80C186EB/80C188EB AND 80L186EB/80L188EB EMBEDDED MICROPROCESSORS SPECIFICATION UPDATE

Release Date: April, 1997
Order Number: 272897-002

Figure 1. Correct INT1 Acknowledge Sequence with Higher Priority Timer Interrupt

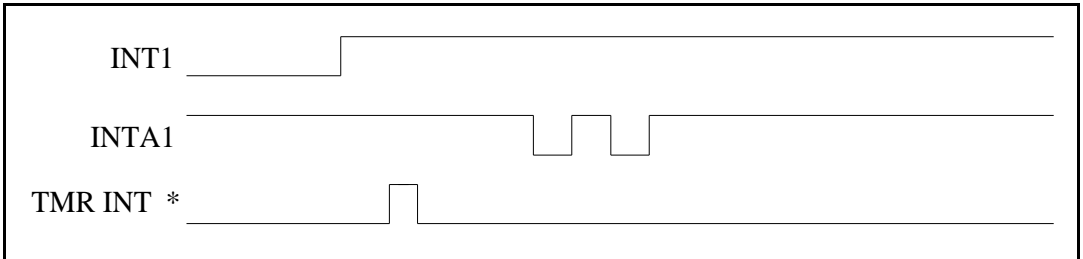
Correct operation of the device acknowledges the interrupt on INTA1# after an interrupt on INT1. Normally, this occurs even if there is a higher priority interrupt after INT1 but before the acknowledge (Figure 1).

Figure 2. Incorrect INT1 Acknowledge Sequence with Higher Priority Timer Interrupt

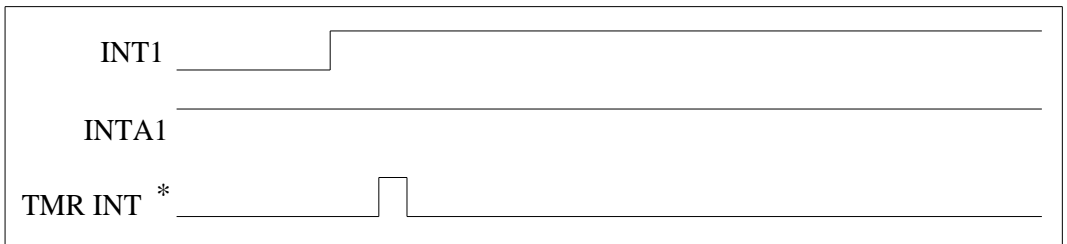
The errata occurs when a higher priority interrupt occurs between INT1 and its expected acknowledge. The processor completes internal interrupt acknowledge cycles as seen on the status lines but no acknowledge cycle is sent on the INTA1# output (Figure 2).

Software Workaround:

| 1. Only INT1 is configured in cascade mode and is lower priority than at least one other interrupt. | Use only INT0 in cascade mode instead, or make INT1 the highest priority interrupt, or use hardware workaround. |

Figure 3. INT0 And INT1 Acknowledge Failure due to Higher Priority Timer Interrupt

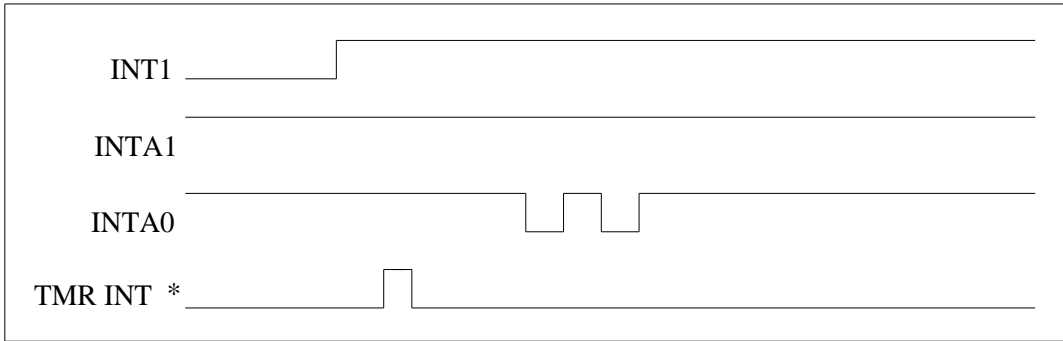
If INT0 and INT1 are configured in cascade mode and a higher priority interrupt occurs between INT1 and its expected acknowledge, then the acknowledge will appear on INTA0# instead (Figure 3).

| 2. INT1 and INT0 are both in cascade mode. | Use only one interrupt in cascade mode, or use hardware workaround. |

Figure 4. Correct INT0 Acknowledge Operation with a Simultaneous INT1

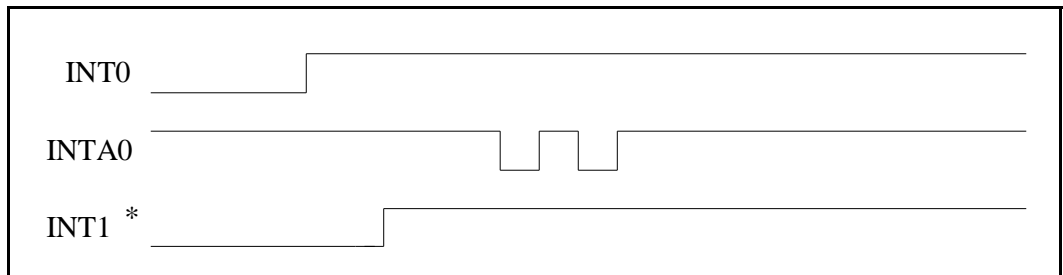
Correct operation acknowledges INT0 on INTA0#. Normally, this occurs even if there is a higher priority INT1 after INT0 but before the acknowledge (Figure 4).

Figure 6. INT0 and INT1 Acknowledge Failure Due to the Higher Priority INT1

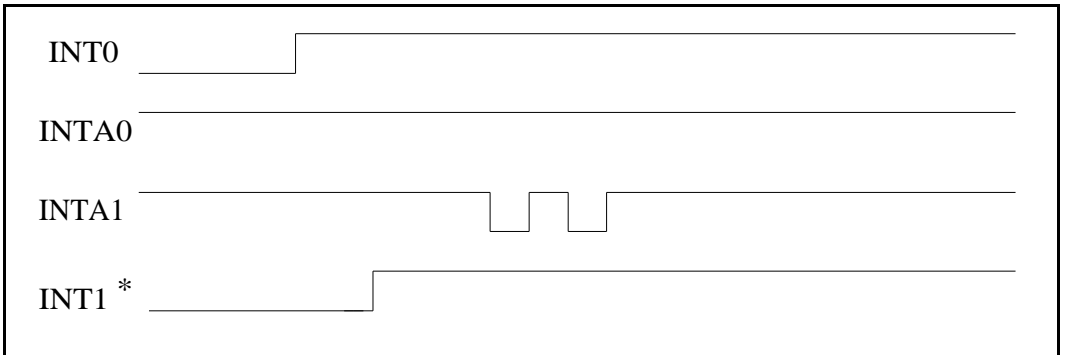
If INT0 and INT1 are configured in cascade mode and the higher priority INT1 occurs between INT0 and its expected acknowledge, then the acknowledge will appear on INTA1# instead of INTA0# (Figure 6).

| 3. Only INT0 is configured in cascade mode and is lower priority than INT1. | Make INT0 higher priority than INT1, or use hardware workaround. |

Figure 7. NMI Ignored During HLT Entering Powerdown

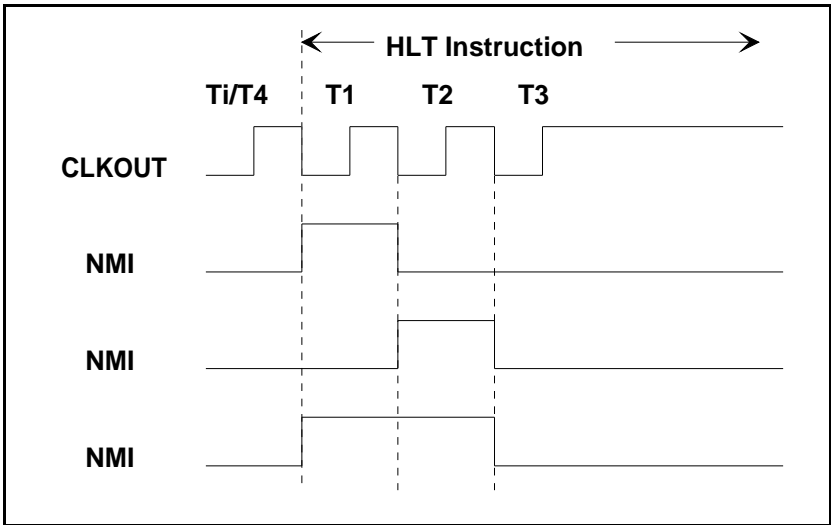
The problem occurs when an NMI occurs during execution of the HLT instruction. NMI is only serviced at valid instruction boundaries. The HLT instruction, when entering Powerdown, does not really have a boundary, it extends until Powerdown is exited. If NMI occurs between the beginning the T1 bus state and the end of the T2 state, but does not extend into T3, it will not be recognized, and the processor will enter Powerdown mode. The processor does not recognize the NMI request during the HLT instruction until the internal clock has stopped (at the end of T2).

The figures below show NMI occurring at different times during execution of the HLT instruction. Two cases are shown. **Figure 7** shows cases where NMI is not recognized. **Figure 8** shows cases where NMI is recognized. Both cases assume setup and hold time requirements are met for the NMI input.

If the system requires periodic NMI pulses, then the NMI pulse width must be long enough to ensure that it will extend into the T3 state of the HLT instruction. A NMI pulse width of three CLKOUT periods guarantees this.

Figure 8. NMI recognized during HLT entering Powerdown

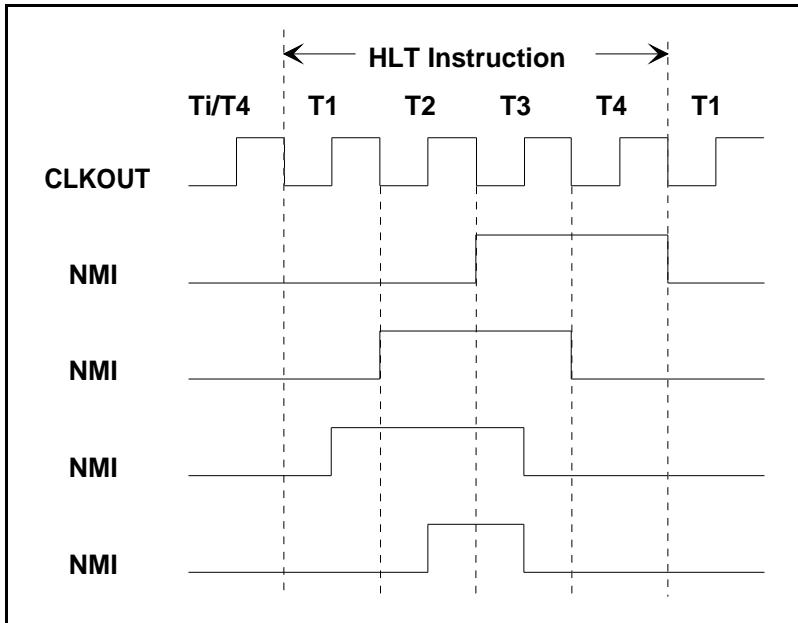
For the NMI to be recognized during the execution of the HLT instruction, the pulse must extend into T3. At this point, the processor has entered Powerdown and synchronized the NMI pulse. The NMI will be processed, but the processor will never enter Powerdown. Essentially, because NMI is active, the processor exits Powerdown as soon as it enters.
